Product Change Notice (PCN)

Subject: Transfer Assembly Location from OSET, Taiwan to Greatek, Taiwan on Select Packages

Revision Description:

Appendix C – Package Outline Drawing Comparizon, SOJ28

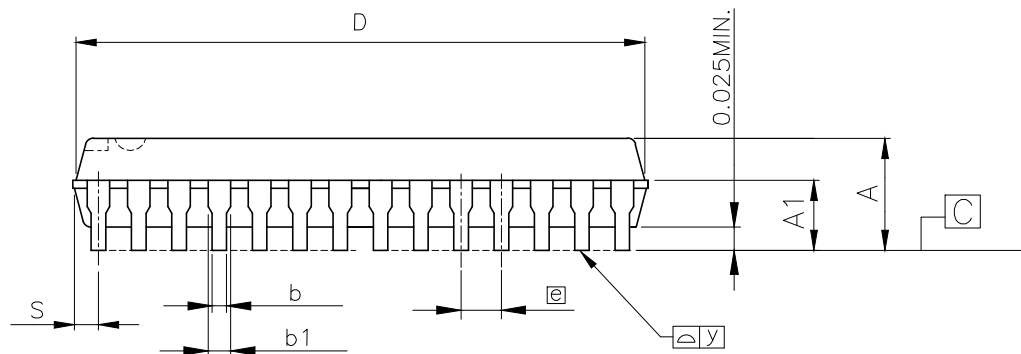
The material sets of the current and new assembly locations are as shown in the below table. The package outline drawing for SOJ28 assembled at Greatek, Taiwan will not meet JEDEC on select dimensions. Refer Appendix C.

Symbols	JEDEC			exIDT POD			Greatek POD			Remark
	MO-088			MO-088			NA			
	MIN	NOR.	MAX	MIN	NOR.	MAX	MIN	NOR.	MAX	
A	0.120	-	0.140	0.120	0.130	0.140	0.120	-	0.140	Greatek meet JEDEC/exIDT
A1	-	-	-	0.078	0.086	0.095	0.820	-	-	Greatek not meet exIDT
A2	0.025	-	-	0.025	-	-	0.025	-	-	Greatek meet JEDEC/exIDT
b	0.014	-	0.020	0.014	-	0.020	0.016	0.018	0.022	Greatek not meet JEDEC/exIDT
c	0.008	-	0.013	0.008	-	0.013	0.008	0.010	0.014	Greatek not meet JEDEC/exIDT
D	0.697	-	0.712	0.700	0.706	0.712	-	0.710	0.730	Greatek not meet JEDEC/exIDT
H	0.335	-	0.347	0.335	0.340	0.347	0.327	0.337	0.347	Greatek not meet JEDEC/exIDT
E	0.292	-	0.300	0.292	0.296	0.300	0.295	0.300	0.305	Greatek not meet JEDEC/exIDT
e1	0.262	-	0.272	0.262	0.267	0.272	0.245	0.265	0.285	Greatek not meet JEDEC/exIDT
e	-	0.050	-	-	0.050	-	0.044	0.050	0.056	Greatek meet JEDEC/exIDT
